## IDAP REPORT

<b>Property:</b>	10 Myall Crescent, Strathfield Lot 10 in DP 236435 DA2021.203
<b>Proposal:</b>	Demolition of existing structures and construction of two storey dwelling house with pool and front fence.
<b>Applicant:</b>	Cedar Designs
<b>Owner:</b>	W Fakh and C Attar
<b>Date of lodgement:</b>	18 August 2021
<b>Notification period:</b>	30th August 2021 to 15th September 2021
<b>Submissions received:</b>	Nil
<b>Assessment officer:</b>	L Fanayan
<b>Estimated cost of works:</b>	\$1,135,062.00
<b>Zoning:</b>	R2-Low Density Residential - SLEP 2012
<b>Heritage:</b>	No
<b>Flood affected:</b>	Yes
<b>RECOMMENDATION OF OFFICER:</b>	<b>APPROVAL</b>

**Figure 10: Landscape Plan**

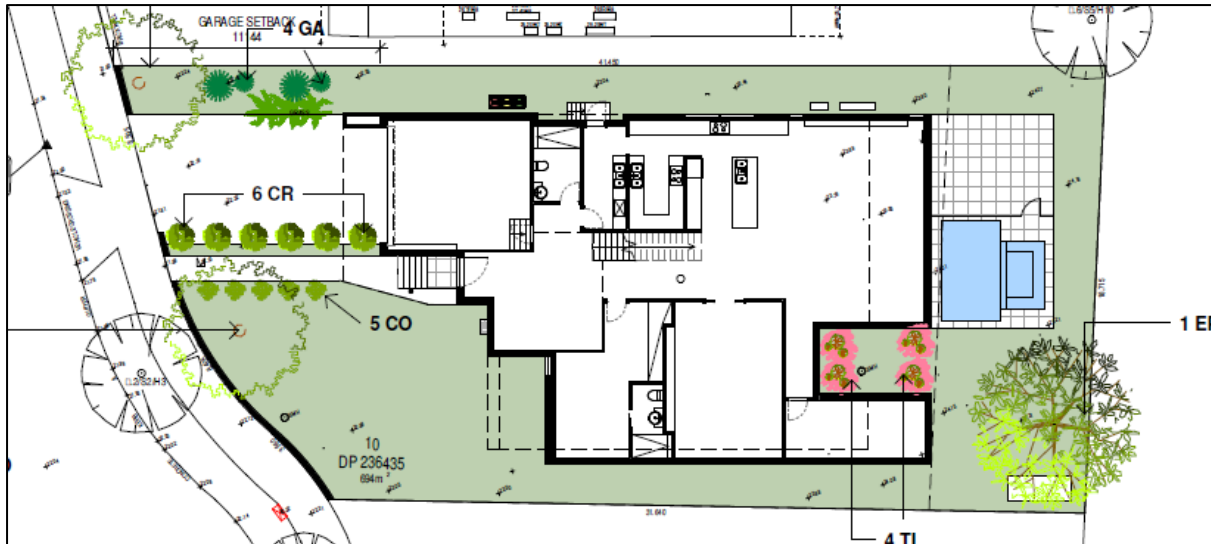
To reinforce the provision of quality landscaping areas, conditions are recommended to change the landscape plan to replace the two (2) Eucalyptus Botryodes in the front yard with two (2) trees that are capable of achieving 15m in order to achieve the conditions of DA 2021/21 (a list is provided in DA2021/21 Notice of Determination conditions).

Landscape Plan	Amend the landscape plan to replace the two (2) Eucalyptus Botryodes in the front yard with two (2) trees that are capable of achieving 15m in order to achieve the conditions of DA 2021/21.
Front Fence	Reduce the overall proposed fence height by 0.2m across its length. The solid components would then measure 1m at the northern corner of the front boundary and 0.7m at the southern corner of the front boundary.

**Figure 18:** Amended void space adjacent to the stairwell and above living room.

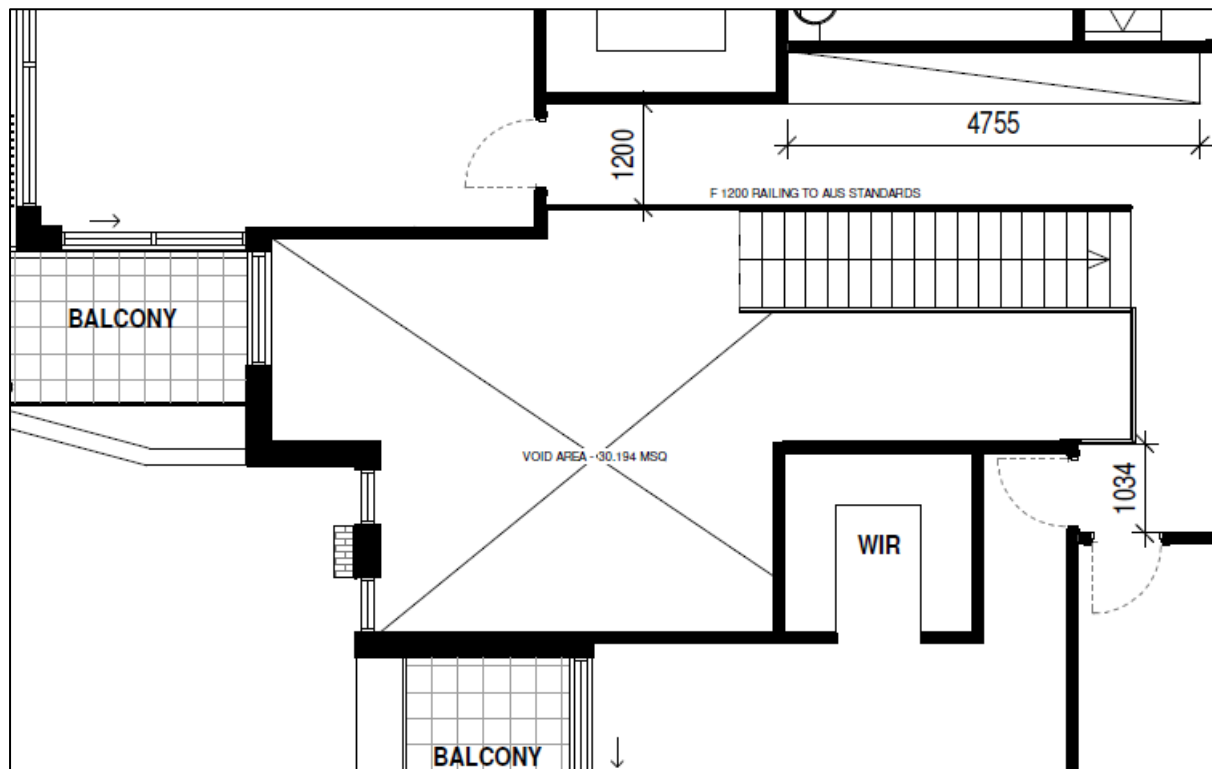
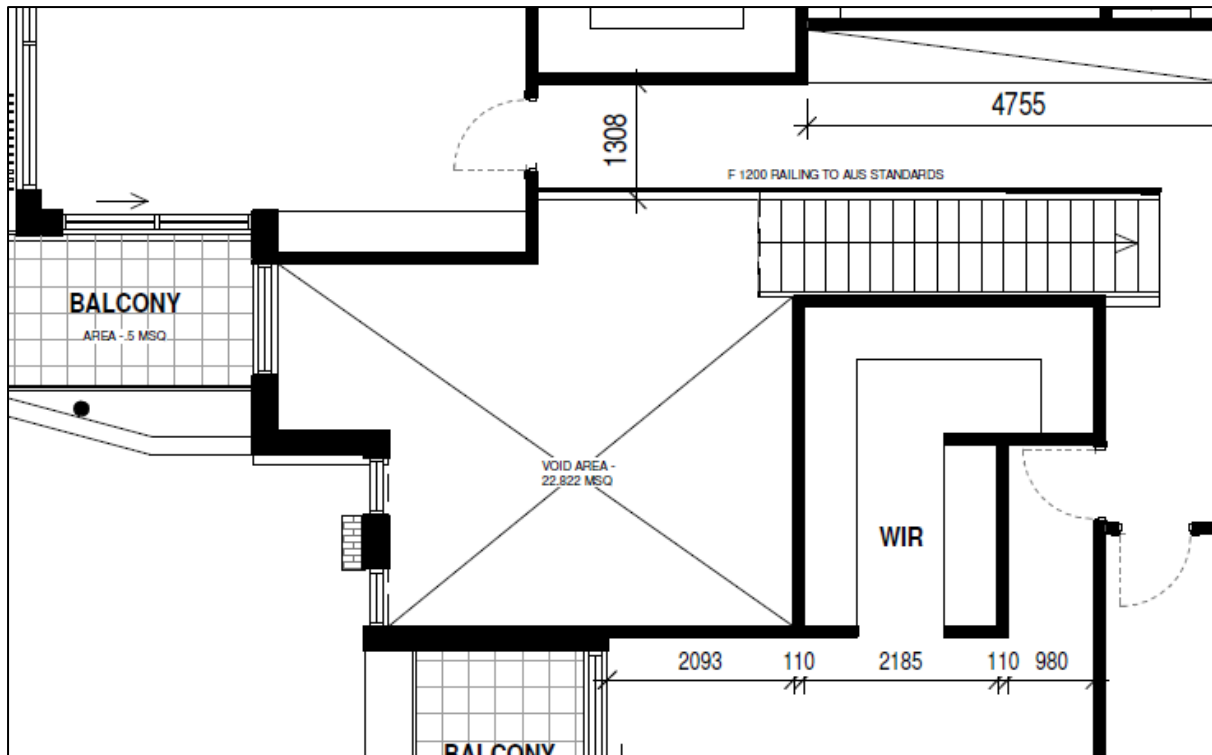
The amended design features an increased northern setback, a reduced void, reduced floor plan on both the ground floor and first floor and a fully compliant floor space ratio (FSR), which has been calculated to not include the garage and void area on the first floor.

This void relates to the formal living room (refer to Figure 18). The amended void space included in the first floor has been reduced from 30.19m<sup>2</sup> to 22.82m<sup>2</sup>.

Although the void space has been reduced through the increase in wardrobe space in both bedroom 1 and 4, the overall Floor Space Ratio has also been reduced in the amended plans from 0.594:1 (412.3m<sup>2</sup>) to 0.582:1 (404.3m<sup>2</sup>). This has been achieved through increasing the northern side setback and reducing the width of the dwelling and ultimately some of its bulk.

The void does provide some additional amenity and additional solar access in winter. Further, the void is recessed from the building line and is broken up by articulated walls to reduce the impact of bulk and massing on the streetscape. The façade and associated void provide visual interest as a feature of design. The void glazing does not face the side boundaries.

It is noted that whilst the void was not counted towards gross floor area and FSR it does contribute to the bulk and scale of the built form. The proposal is not at the limit of FSR for this site and on balance, this void is considered an acceptable component given that it provides additional amenity. A condition will be imposed to ensure this void remains a void in perpetuity.

**Figure 18:** East elevation showing cut from the rear yard

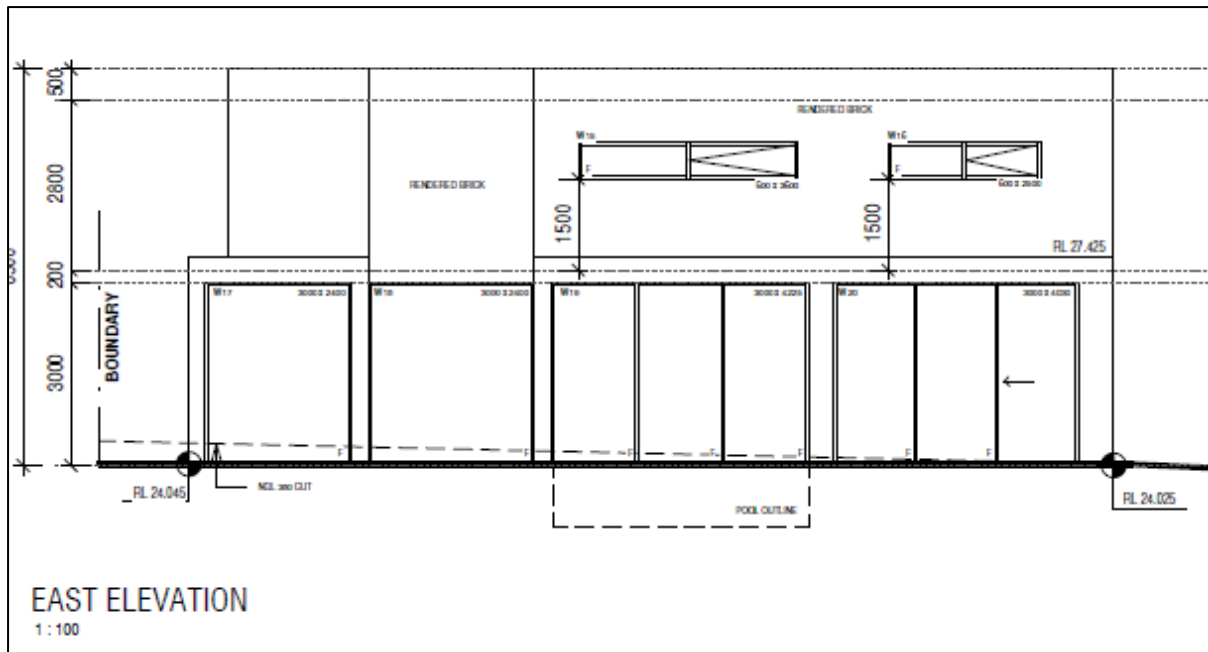
The proposed development is considered to satisfy the relevant objectives and controls of the SCDCP 2005. In order to provide a level the site for development it is proposed for a maximum cut of 0.38m on the south-eastern portion of the site and 0.547m on the north-western portion of the site. It is consider that cut and fill has been kept to a minimum to provide a developable foundation for the proposed development. Ground water tables are maintained and impact on overland flow and drainage is minimised.
